DESCRIPTIVE REPORT

Topographic } Sheet No. T5052 **5052**
Hydrographic }

South Shore of Long Island

REVIEW OF PHOTO TOPOGRAPHIC SURVEY NO. T5052

REVIEW OF AIR PHOTO SHEET 5052

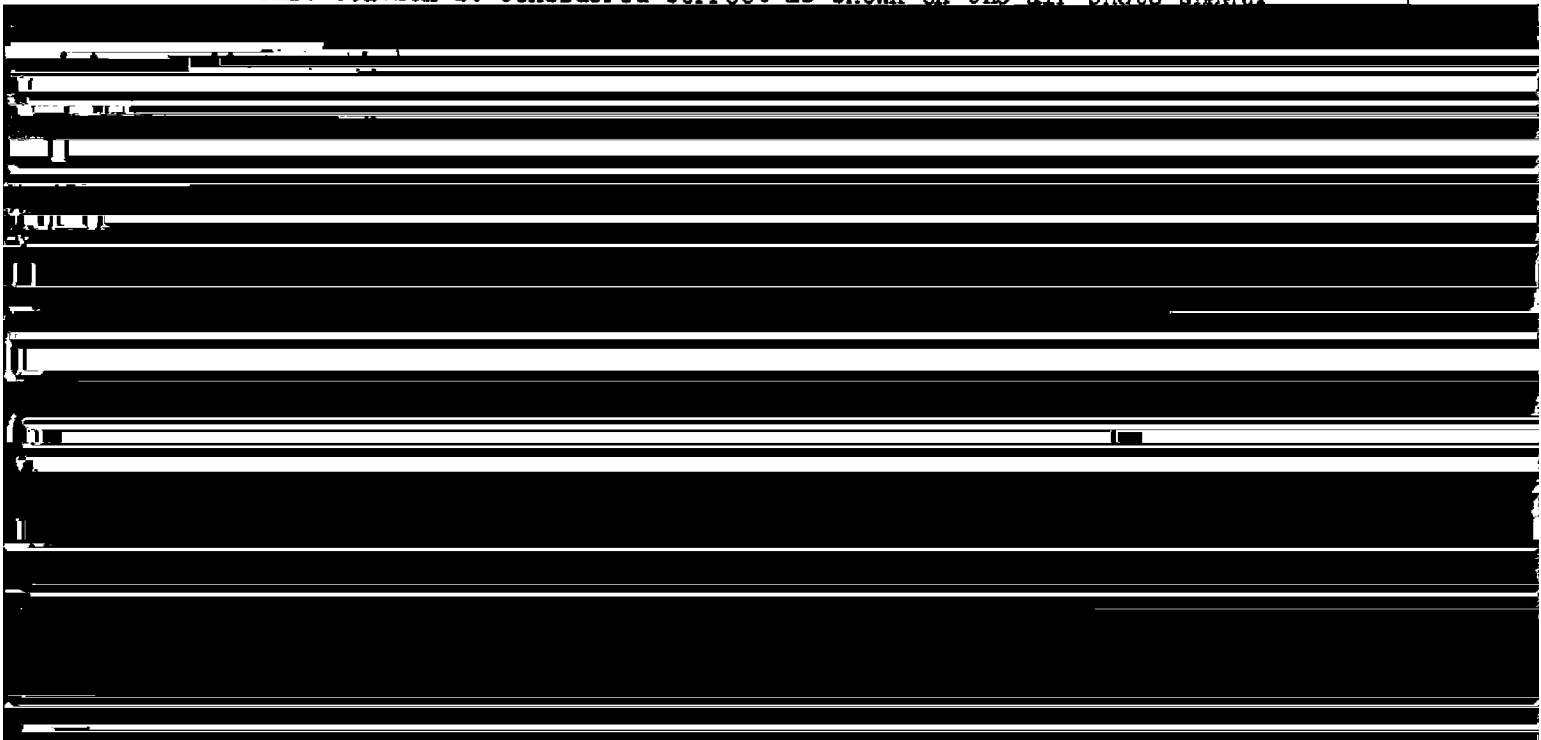
The topographic stations in question were located on planetable control sheets T 4763 and T 4764. The large holes pricked for triangulation and topographic station points and the triangles of error shown by the penciled cuts on those sheets do not indicate careful planetable work and will no doubt account for some of the differences mentioned.

Station "War": Latitude $40^{\circ}-48.4'$, Longitude $72^{\circ}-38.5'$ (T 4764). Since the spotting of this point on the photographs is questioned, the air photo location may be for another pole, though that seems doubtful. However, the air photo sheet gives a larger scale and more detailed plot of the slough and bridge, and shows the bridge in a slightly different location on this sheet. The 4 ft. sounding ^{Pos. 105 E} shown at station "War" on H 5323, will plot on the shore line as located on this sheet. The shore line and bridge as shown here are considered the better location and should be transferred to the hydrographic sheet and the sounding adjusted accordingly. *Transfer affected. H. W. H.*

Station "Sox": Latitude $40^{\circ}-48.4'$, Longitude $72^{\circ}-39.9'$ (T 4764). The hole pricked for the station point on the planetable sheet is about .4 M M in diameter. The air photo location is ^{accepted} considered correct. The fact that the station is on the wing prints of the photographs is not a determining factor as the photo plot checked on two triangulation stations and on several planetable stations in this immediate vicinity. The air photo location of this station and the wharf should be transferred to the H 5323 where a line of soundings runs very close to the outer edge of the wharf.

Station "Mul": Latitude $40^{\circ}-48.8'$, Longitude $72^{\circ}-43'$ (T 4764). This station is considered correct as shown on the air photo sheet.

Stations "Jam", "Rut", and "Bon" do not appear on the Hydrographic Sheet H 5322 and any error in the plane table locations will not affect the soundings. Station "Mit" is plotted on H 5322.

Stations "Rut", "Bon" and "Mit" are shown on the 1:20,000 plane table sheet T 4764. The review attached to the descriptive report of that sheet lists discrepancies and indications of careless plane table work which accounts for at least part of the differences in location of these stations. Station "Jam" is shown on T 4763 (1:10,000-1933).

Station "Bon" - The photographs are somewhat blurred here but careful examination under the stereoscope shows definitely that only one steeple exists on this church and examination of the radials drawn on the photographs shows that the steeple was correctly spotted and was located on the sheet. The object confused by the compiler as a twin steeple is a tree and was not located on the sheet. The difference in location is not due to faulty spotting and the air photo position is accepted since the plot was on a scale of 1:10,000, was well controlled, and agrees with the plane table sheet for location of other objects in this area. On plane table sheet T 4764 only one cut is visible and the difference is in approximately the same direction as that cut. The plane table location appears to have been made one cut and a rod reading.

Stations "Rut" and "Mit" - The photographs have been examined and while they are somewhat blurred the wind mill and the tank can both be seen and the radials are shown thru the correct positions on the photographs. The differences are not due to faulty spotting and the air photo location of both these stations is accepted for the same reasons stated in the preceding paragraph. On the plane table sheet T 4764 the hole pricked for station "Rut" is about 8 meters in diameter and for station "Mit" the hole is about 8 meters in diameter with a triangle of error in the cuts of 12 meters across.

Station "Jam" - This object does not show on the photographs and the spotting is not exact. The difference in location is about 4 meters instead of 7 meters given in the descriptive report. The photo position has been changed on the compilation to agree with the plane table.

Bridges: See Page 6 of the preceding report. The clearances noted on the plane table sheets T 4763 and T 4764 (1933) for bridges over Quantuck Creek, just west of Quantuck Creek, and over the slough at West Hampton Beach were shown by the compiler but have been removed from the compilation. These clearances were noted on the plane table sheets in pencil with no notice as to the plane of reference and no mention in the descriptive reports.
